## Arboricultural Construction Impact Assessment

**66 & 72 Miller St, Preston VIC 3072**

Date of Report 8/03/2024

The design is a proposed childcare development.

PROPOSED CHILDCARE DEVELOPMENT  
 66 & 72 MILLER STREET,  
 PRESTON, VIC. 3072.  
 EXISTING AND DEMOLITION PLAN  
 Date. 07.03.24 Drawn. LJ  
 Job No. 3253 Scale@A1 1 : 100

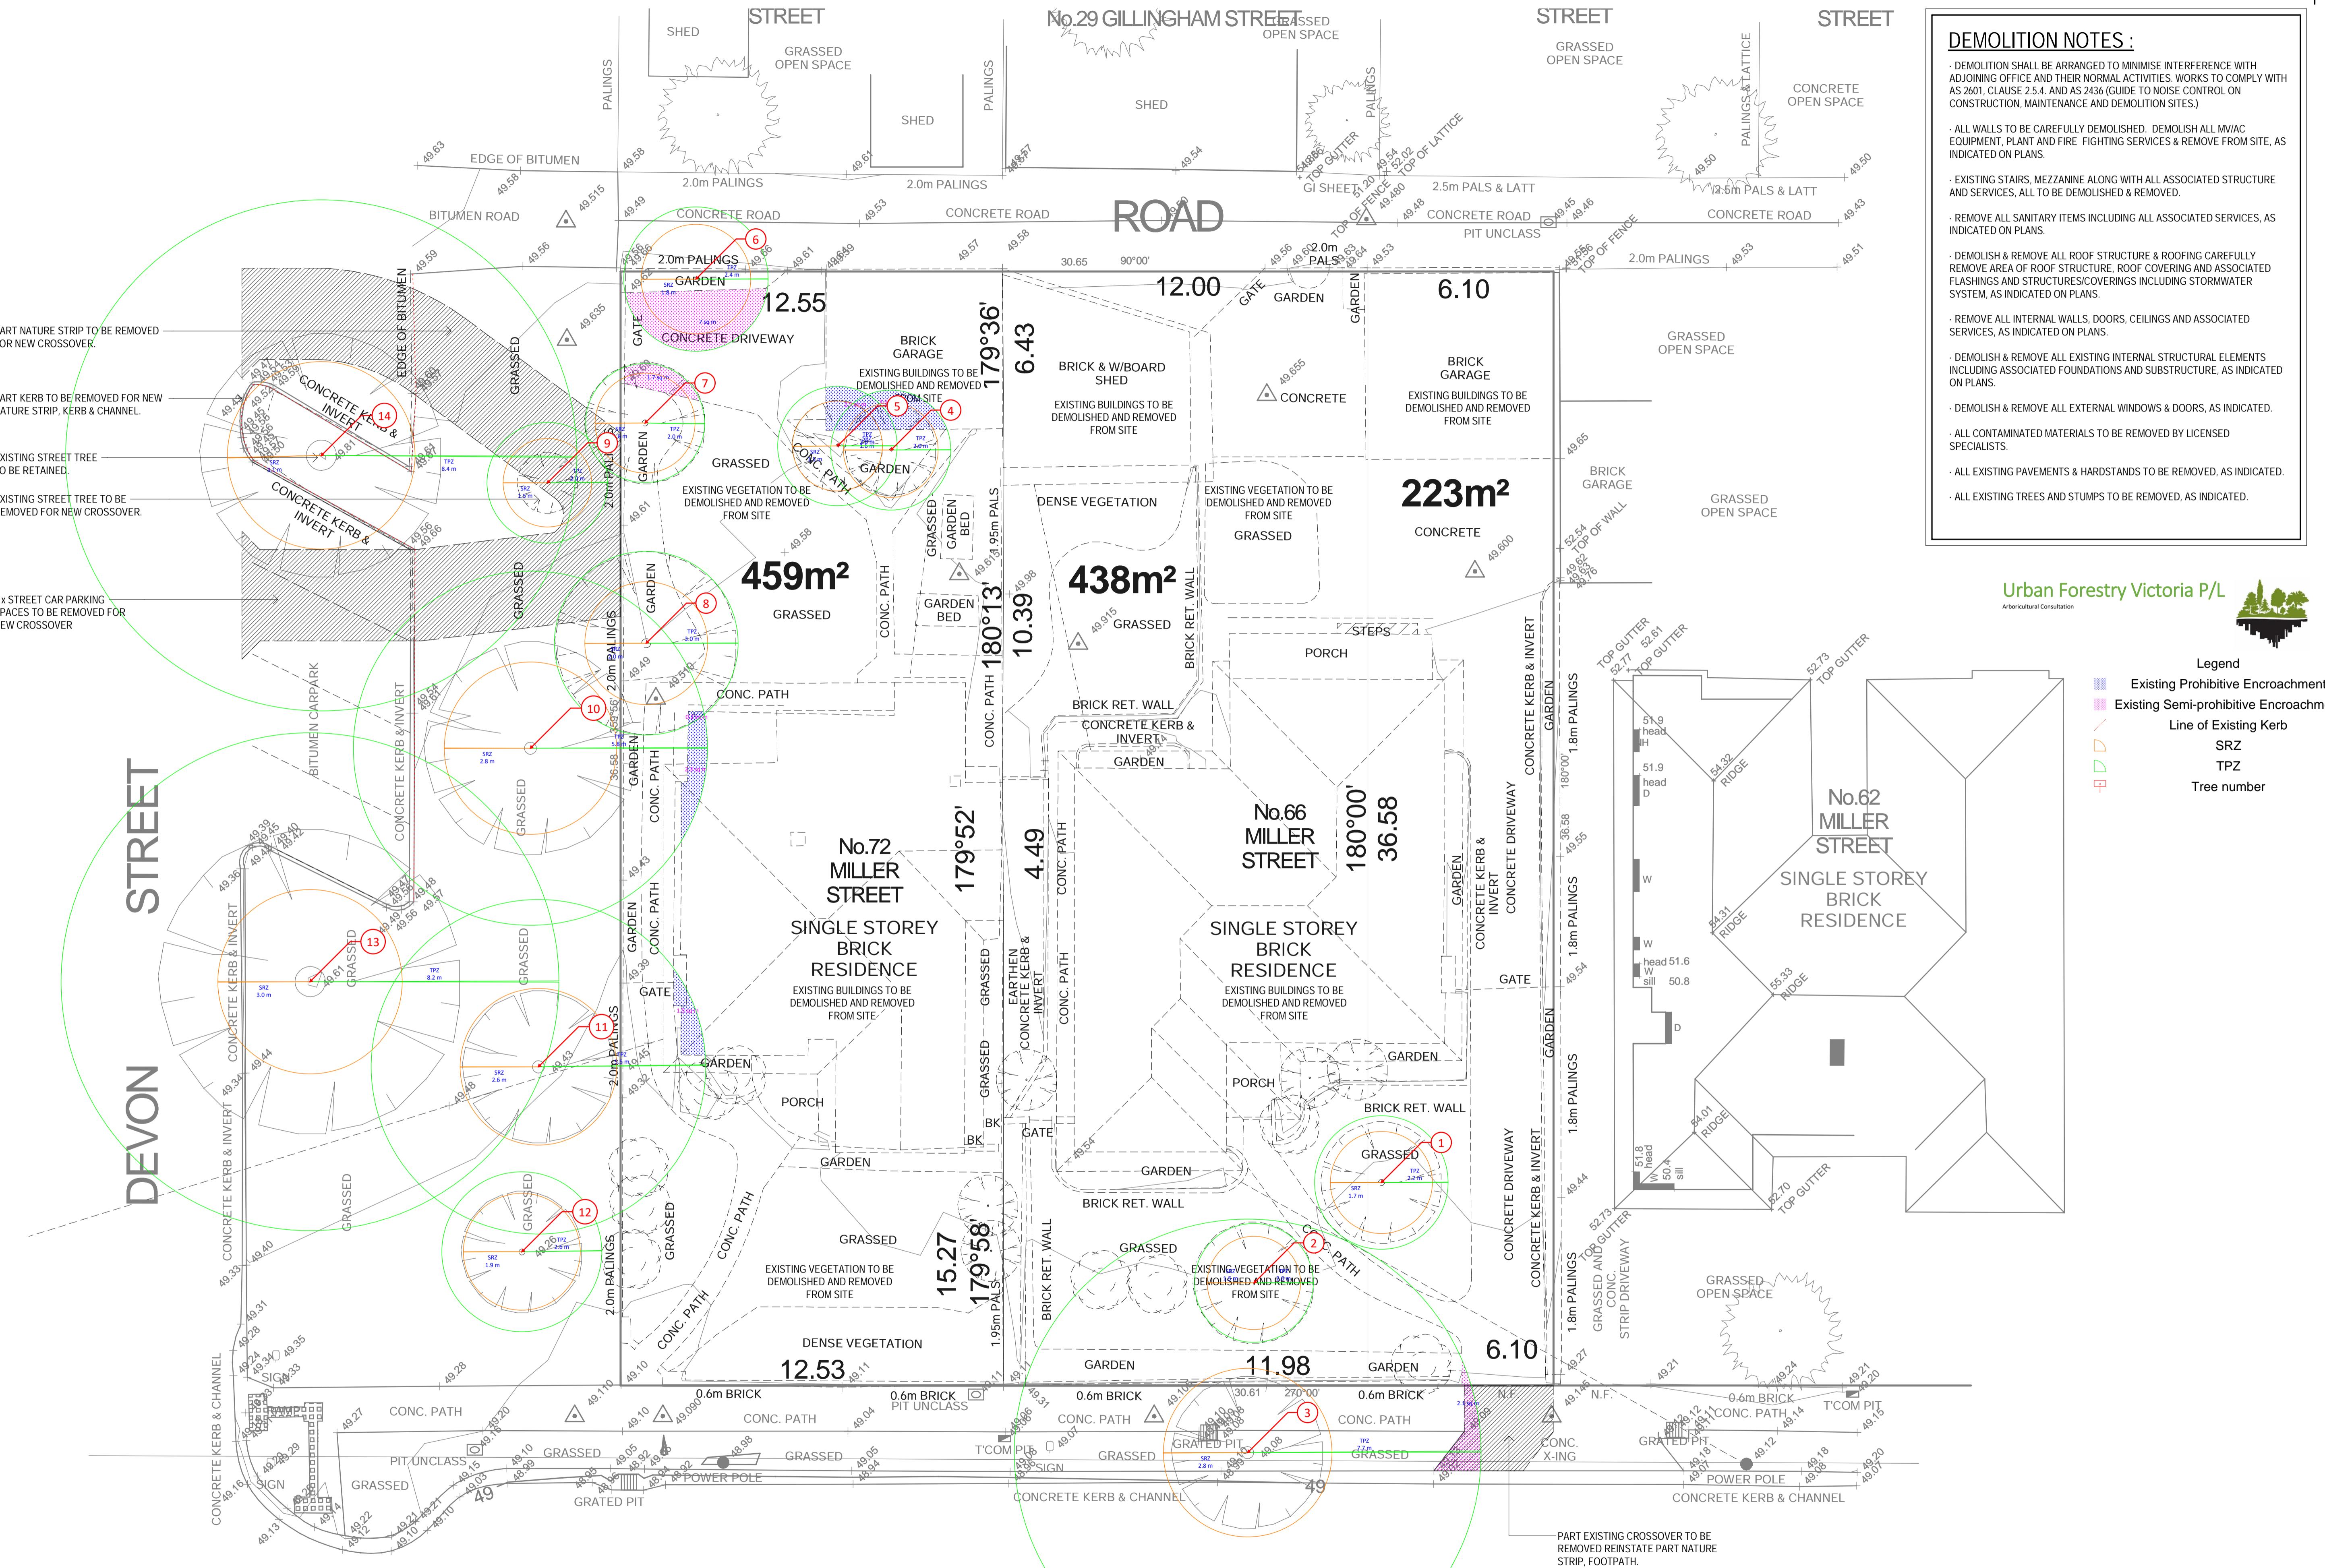
There is 3.5m<sup>2</sup> existing prohibitive encroachment within the TPZ from the brick garage.

There is 2.5m<sup>2</sup> existing prohibitive encroachment within the TPZ from the brick garage.

There is 7.0m<sup>2</sup> existing semi-prohibitive encroachment within the TPZ from the concrete driveway.

There is 1.7m<sup>2</sup> existing semi-prohibitive encroachment within the TPZ from the concrete driveway.

There is 0.2m<sup>2</sup> existing prohibitive encroachment within the TPZ from the brick residence.

SED CHILDCARE DEVELOPMENT  
MILLER STREET,  
ON, VIC. 3072.  
SED SITE PLAN  
7.03.24 Drawn. LJ  
253 Scale @ A1 1 : 100

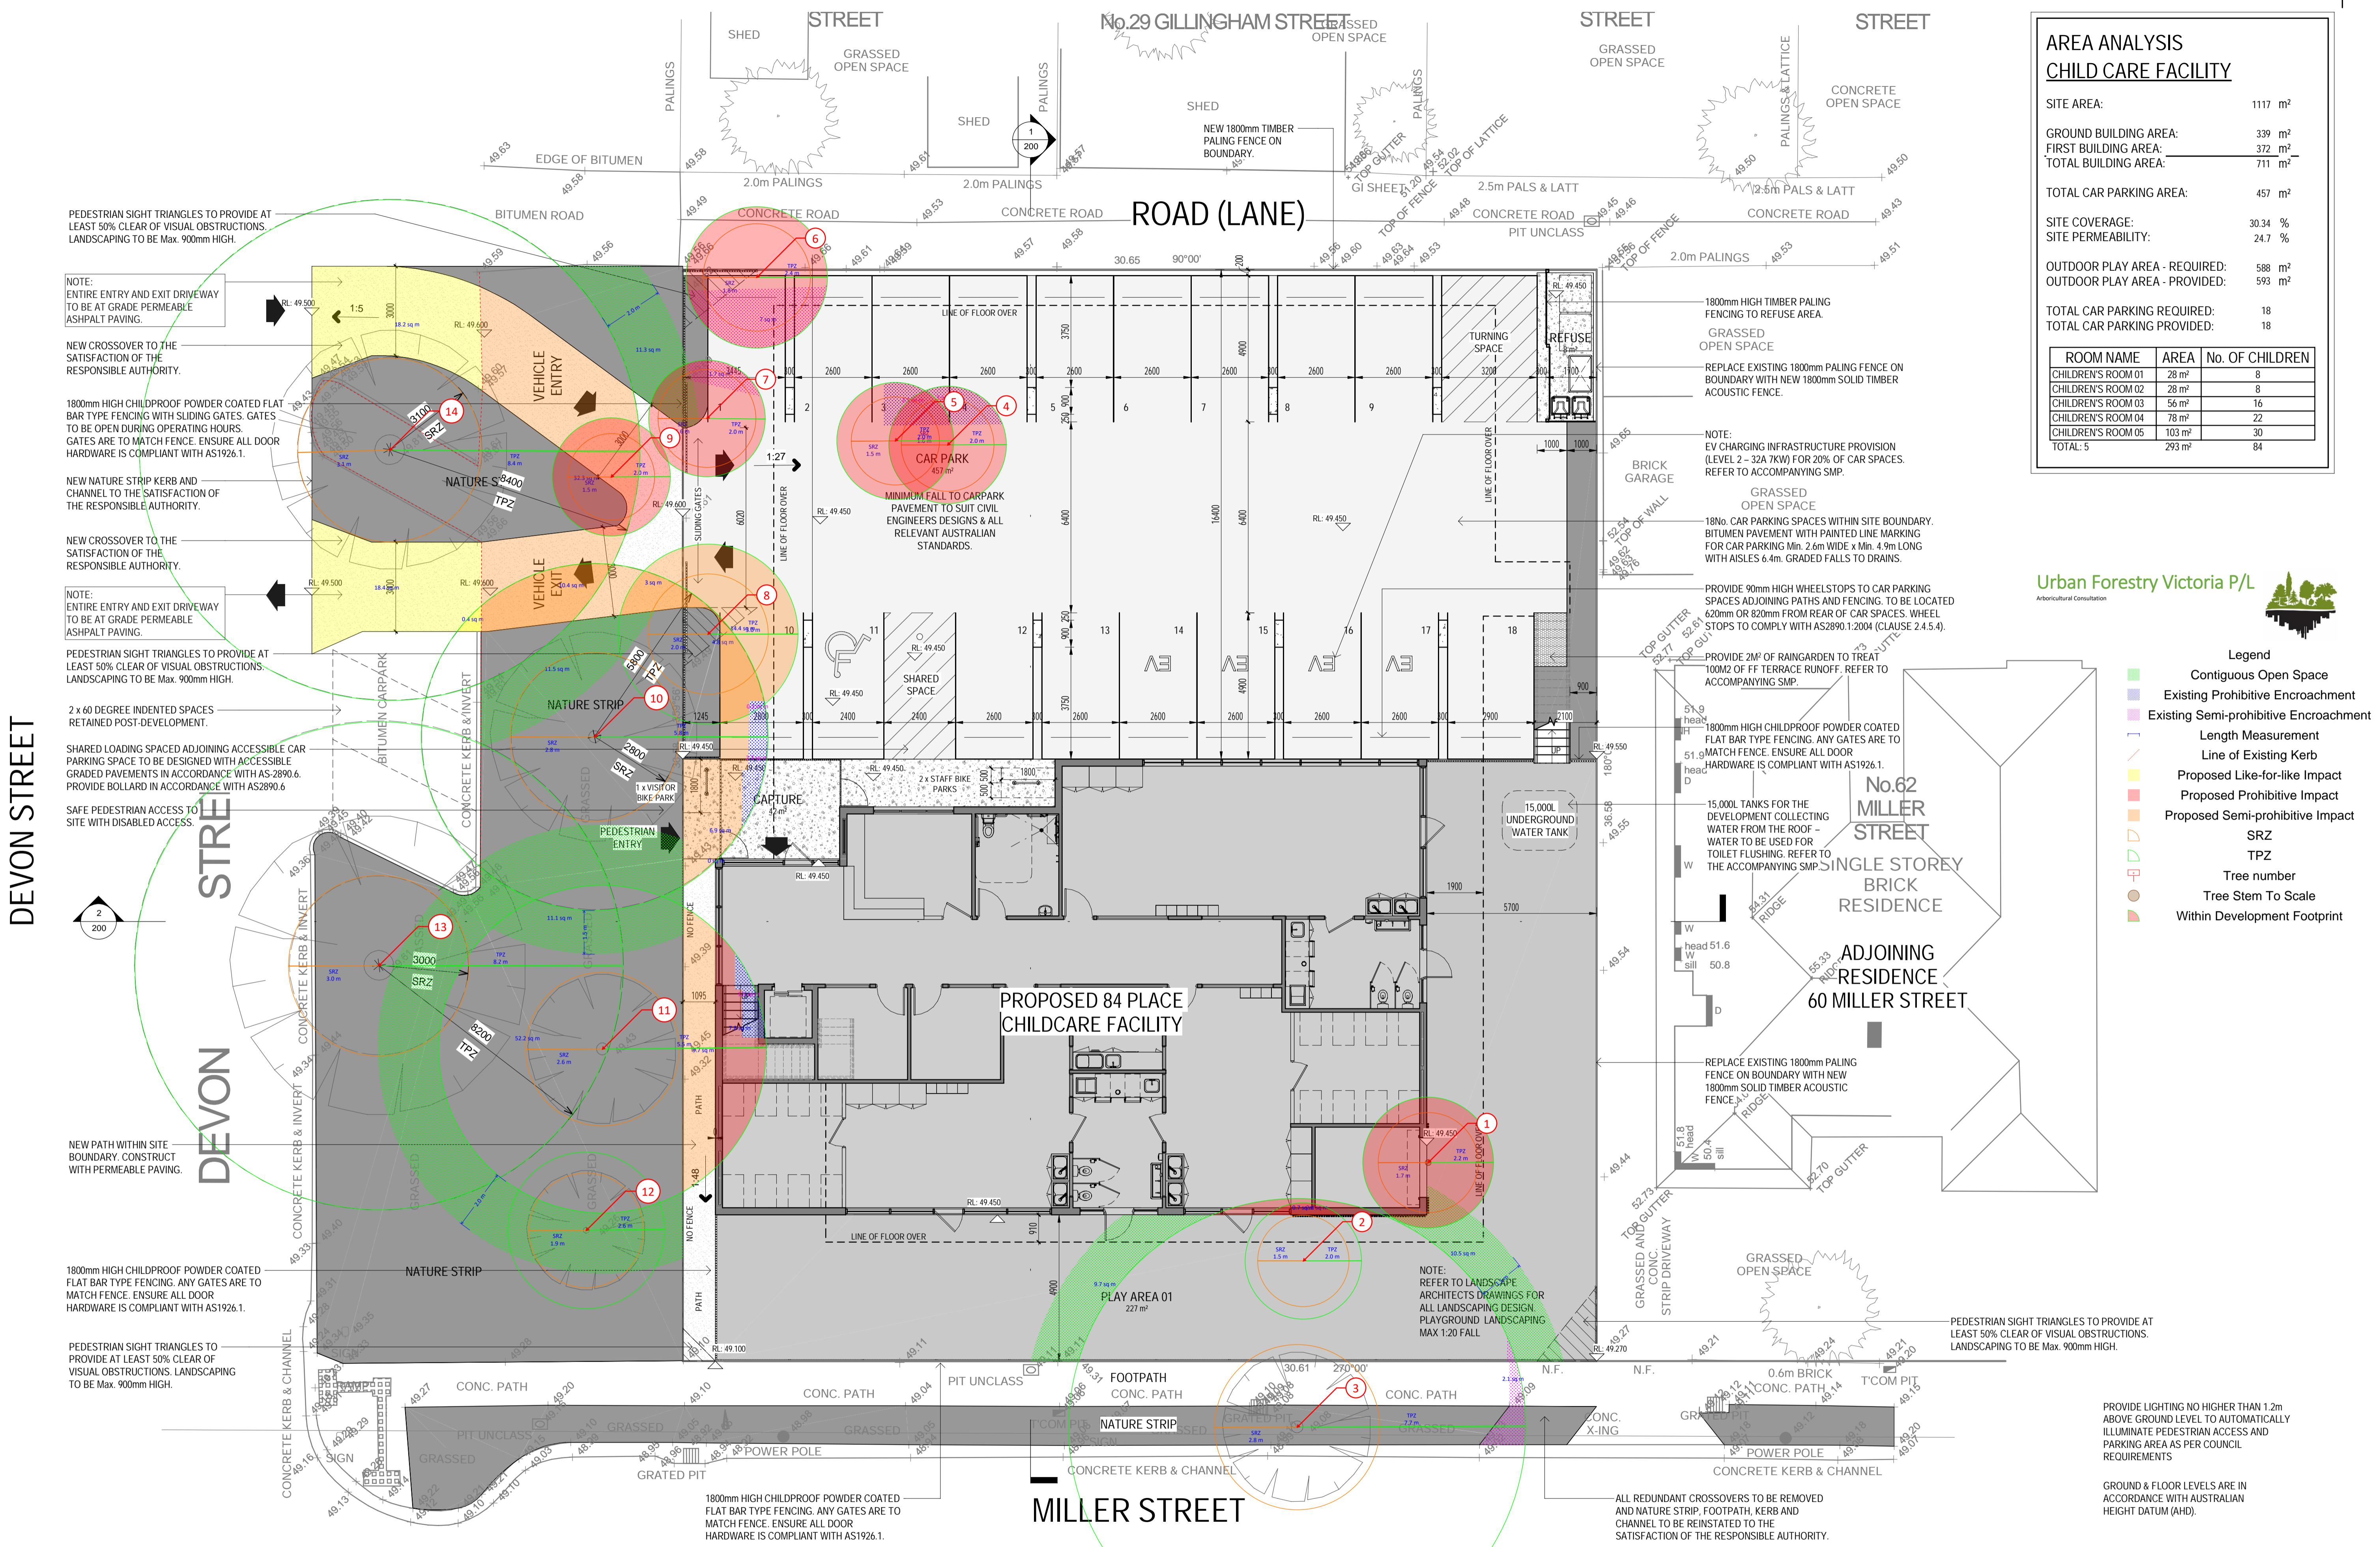
Within the context of the proposed design, the tree will incur an approximate 17.4m<sup>2</sup> (64%) combined TPZ area impact and an impact of the SRZ from the proposed

- Crossover, 3.0m<sup>2</sup> (11%) semi-prohibitive impact (SRZ impact)
- Car park, 14.4m<sup>2</sup> (53%) semi- prohibitive impact (SRZ impact)

Within the context of the proposed design, the tree will incur an approximate 22.5m<sup>2</sup> (22%) combined TPZ area impact from the proposed

- Crossover (west of kerb), 0.4m<sup>2</sup> (<1%) like-for-like impact
- Crossover (east of kerb), 10.4m<sup>2</sup> (10%) semi-prohibitive impact
- Car park, 4.8m<sup>2</sup> (5%) semi-prohibitive impact
- Pedestrian entry, 6.9m<sup>2</sup> (7%) semi-prohibitive impact

This is a major TPZ area encroachment in accordance with AS4970-2009. The tree is proposed to be retained, however, may not remain viable within the context of the proposed design. For the viable retention of the tree within the context of developing the subject site, it will be necessary to implement the following recommendations.

- **Tree 11** is a mature, Australian native Prickly Paperbark of medium to high retention value and moderate significance, located in the road reserve of Devon St. The tree is of typical health and structure for its species, age, and location. There is 1.5m<sup>2</sup> existing prohibitive encroachment within the TPZ from the brick residence. Within the context of the proposed design, the tree will incur an approximate 17.5m<sup>2</sup> (18%) combined TPZ area impact and an impact of the SRZ from the proposed

- a) Childcare facility, 7.8m<sup>2</sup> (8%) prohibitive impact
- b) Path, 9.7m<sup>2</sup> (10%) semi-prohibitive impact

This is a major TPZ area encroachment in accordance with AS4970-2009. The tree is proposed to be retained, however, may not remain viable within the context of the proposed design. For the viable retention of the tree within the context of developing the subject site, it will be necessary to implement the following recommendations.

- Tree 14 is a mature, Victorian native River Red Gum of high retention value and high significance, located in the road reserve of Devon St. The tree is of typical health and structure for its species, age, and location. There is existing semi-prohibitive encroachment within the TPZ from the concrete kerb, asphalt parking bay, and road. Within the context of the proposed design, the tree will incur an approximate 68.9m<sup>2</sup> (31%) combined TPZ area impact from the proposed
  - Crossover (north of Tree 14, west of kerb), 18.2m<sup>2</sup> (8%) like-for-like impact

- b) Crossover (south of Tree 14, west of kerb), 18.4m<sup>2</sup> (8%) like-for-like impact
- c) Crossover (east of kerb), 32.3m<sup>2</sup> (15%) semi-prohibitive impact

This is a major TPZ area encroachment in accordance with AS4970-2009. The tree is proposed to be retained, however, may not remain viable within the context of the proposed design. For the viable retention of the tree within the context of developing the subject site, it will be necessary to implement the following recommendations.

- 1) Prior to any excavation occurring for the crossover, a trench must be dug by hand or by other non-destructive means (pneumatic, or hydro-excavation) along the south edge of the vehicle exit within the TPZ of Tree 10 to the same depth as the proposed road base. During the works:

- 2) Prior to any excavation occurring for the car park and pedestrian entry, a trench must be dug by hand or by other non-destructive means (pneumatic, or hydro-excavation) along the west edge of the car park and pedestrian entry within the TPZ of Tree 10 to the same depth as the proposed sub base. During the works:

- 3) All surfaces within the TPZ of Tree 10 must be constructed at the existing natural grade. Excavation must not exceed the minimum amount required to achieve a vegetation site scrape.
- 4) All surfaces within the TPZ of Tree 10 must be constructed with a permeable material.
- 5) No in-ground services must be installed within the TPZ of Tree 10.

- 1) Prior to any excavation occurring for the path, a trench must be dug by hand or by other non-destructive means (pneumatic, or hydro-excavation) along the west edge of the path within the TPZ of Tree 11 to the same depth as the proposed sub base. During the works:
  - a. Excavation must be supervised by the Project Arborist.
  - b. Any roots found must be pruned at the edge of the trench closest to the tree using sharp saw or secateurs. Any machinery not specifically designed to prune roots must not be used.
  - c. Any exposed roots must not be allowed to desiccate. Exposed roots must be covered with pre-moistened thick hessian or jute matting and pinned. The covering must be kept moist until such a time as the roots are permanently covered.

2) The path within the TPZ of Tree 11 must be constructed at the existing natural grade. Excavation must not exceed the minimum amount required to achieve a vegetation site scrape.

3) The path within the TPZ of Tree 11 must be constructed with a permeable material.

4) No in-ground services must be installed within the TPZ of Tree 11.

- 1) Prior to any excavation occurring for the crossover, a trench must be dug by hand or by other non-destructive means (pneumatic, or hydro-excavation) along the edge of the vehicle entry and exit closest to the tree, within the TPZ of Tree 14 to the same depth as the proposed road base. During the works:

- 2) All surfaces within the TPZ of Tree 14 must be constructed at the existing natural grade. Excavation must not exceed the minimum amount required to achieve a vegetation site scrape.

- 3) All surfaces within the TPZ of Tree 14 must be constructed with a permeable material.
- 4) No in-ground services must be installed within the TPZ of Tree 14.
